Re: Variance Application 07-0716; Smith
23600 Gross Drive

DATE: November 9, 2007
TO: Denis Canavan, Director
FROM: Yvonne Chaillet, Zoning Administrator
Jenn Ballard, Environmental Planner
SUBJECT: AD VAAP # 07-0716, Smith – Septic System Replacement
Administrative Hearing of November 8, 2007
Supplemental Report

Sewage Disposal System
Kingston Manor - Lot 20
23600 Gross Drive, California, Maryland
Tax Map 35, Block 7, Parcel 138
for: Paul DiBenedetto
8th Election District St. Mary's Co., Maryland

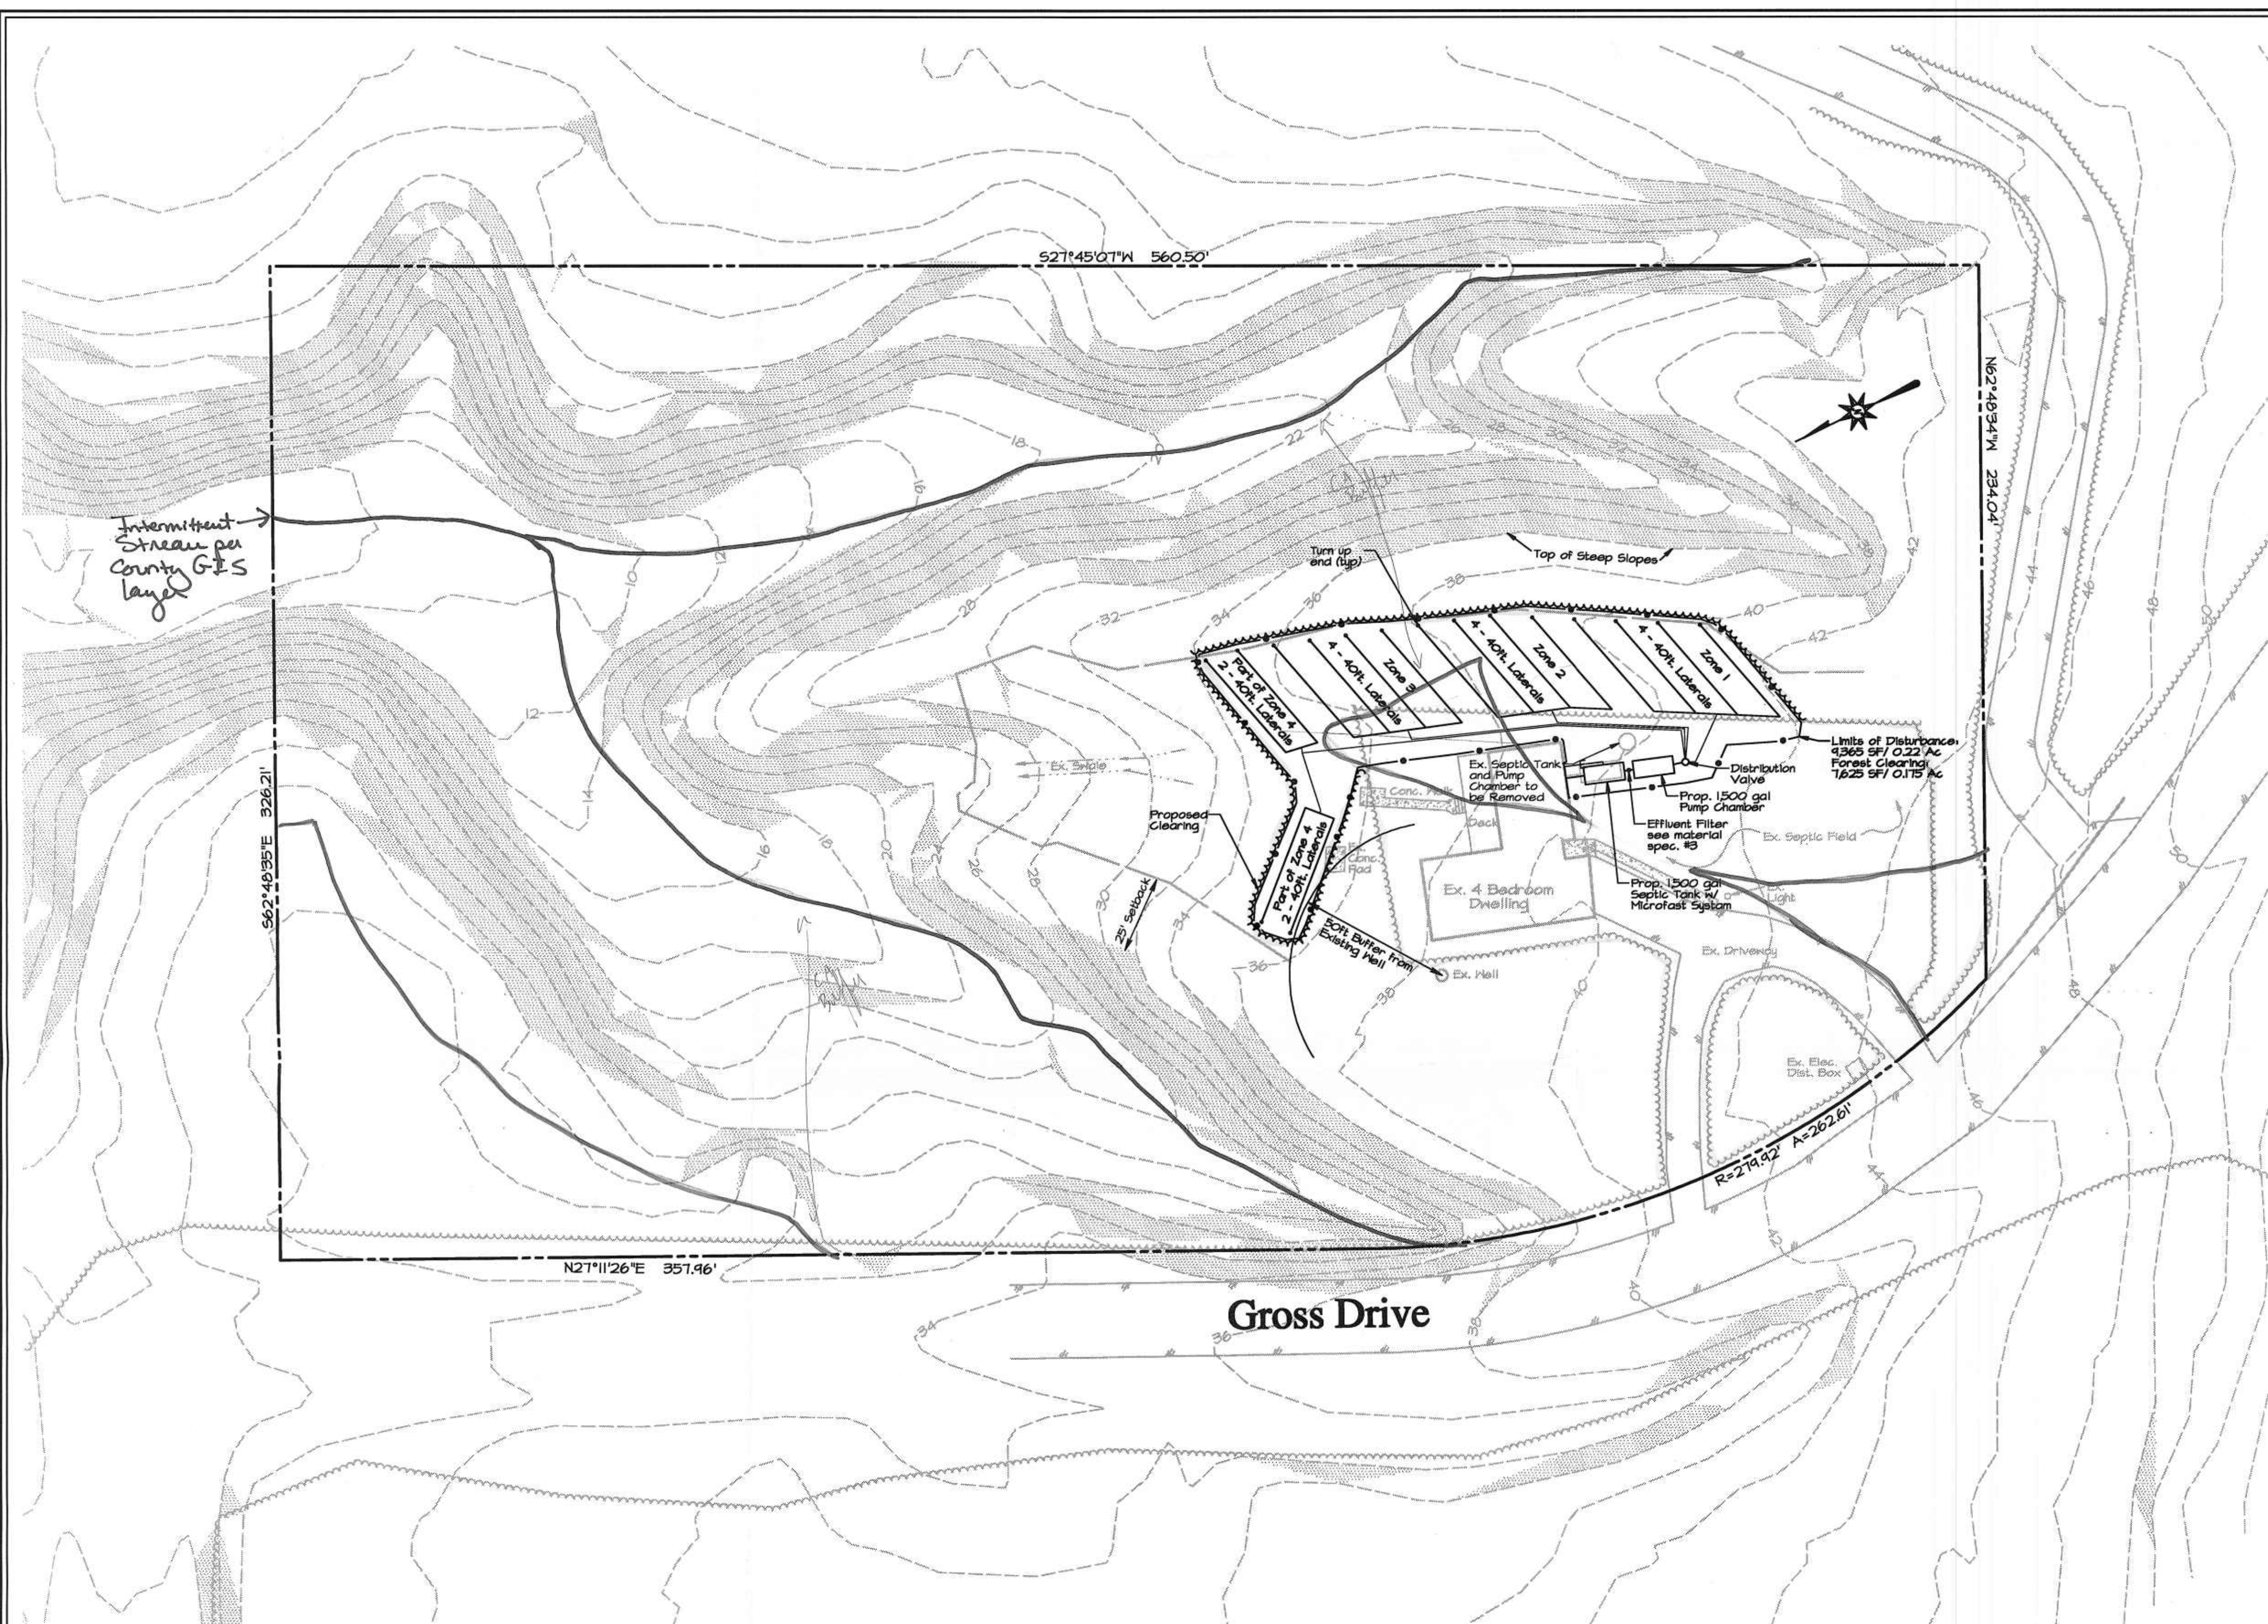
Based on the information provided, this office does not oppose this request. Due to the presence of two tributary streams and adjacent steep slopes and highly erodible soils, nearly the entire property is located within the Buffer or expanded Buffer. Given other constraints on the site including the location of the well, the selected area is the only place available to install the replacement septic system. Finally, the submittal includes mitigation at a ratio of 3:1 for the area of disturbance within the Buffer. As a condition of approval, I recommend the Board of Appeals require the applicant apply to Maryland Department of the Environment's Bay Restoration Fund for financial assistance to upgrade the proposed system using denitrification technology. They may contact Shan Abeywickrama at 410-537-3921 for further information.

4. The Health Department and Soil Conservation District approved the site plan on October 18, 2007 and August 24, 2007 respectively. The Critical Area Commission does not oppose the variance request, but recommends that the Applicant upgrade the septic system to include de-nitrification technology. The County, however, does not have regulations or a process in place to address de-nitrification.

A strict enforcement of the Critical Area provisions of the Ordinance would prohibit any new development activities in the Critical Area Buffer. The only portions of the lot that are outside the Buffer are occupied by the existing house, existing septic field and a portion of the replacement septic system. In fact, there is little room outside the Buffer to construct or install anything.

- V. **STAFF RECOMMENDATION:** Staff finds that the Applicant has met the Standards for granting a variance in the Critical Area and recommends approval of VAAP #07-0716 to clear vegetative cover and install a septic system in the Critical Area Buffer, subject to the Applicant complying with the Critical Area Planting Agreement.
